**Subject: Modification 5 Bloomfield Colliery Continuation Project (MP07\_0087-Mod-5) – Response to Submissions**

## Attachment 1 - CPHR Comments on Modification 5 Bloomfield Colliery Continuation Project (MP07\_0087-Mod-5) – Response to Submissions

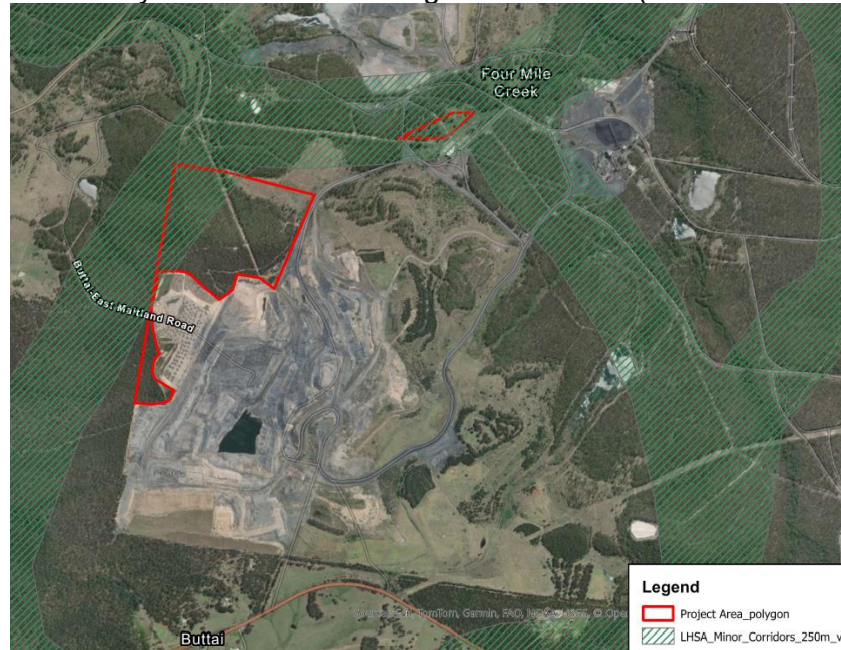
The BDAR must further consider impacts to connectivity. The BDAR does not adequately assess the role of this connection within the wider landscape.

Table 14 of the BDAR states the proposal will have a negligible impact to Koala habitat connectivity. CPHR deems this assessment inadequate

This vegetation has been mapped as minor corridor linking priority habitats by Lower Hunter Strategic Assessment (Drielsma et al. 2014).

Cessnock LGA has also mapped the vegetation as important for biodiversity in their [Environmental lands study for Cessnock LGA](#).

The subject site is linked to the Watagan Stockton Green Corridor which is ecologically significant for the Lower Hunter Koala Population and forms a connection to the Port Stephens Koala Population to the northeast.

Although the site falls just to the north of the Watagan Stockton Green Corridor, it forms an important sub-regional corridor (Scotts, 2003). Scotts (2003) outlines that the minimum benchmark width for a sub-regional corridor is 300m and that the minimum regional corridor width for Koala is 350m.

Office of the NSW Chief Scientist & Engineer provided [expert advice](#) stating koalas need the average minimum width of 390-425 metres, including a buffer within the corridor.

The proposed action will reduce the existing corridor from 500-800m down to 150m in some locations. CPHR recommends that a corridor of approximately 350m width be maintained at a minimum.

Additional assessment of Prescribed Impacts is required, and the habitat connectivity assessment should be revised to include evidence-based justifications for conclusions.

Proponent to adjust footprint in order to consider impacts on habitat connectivity.
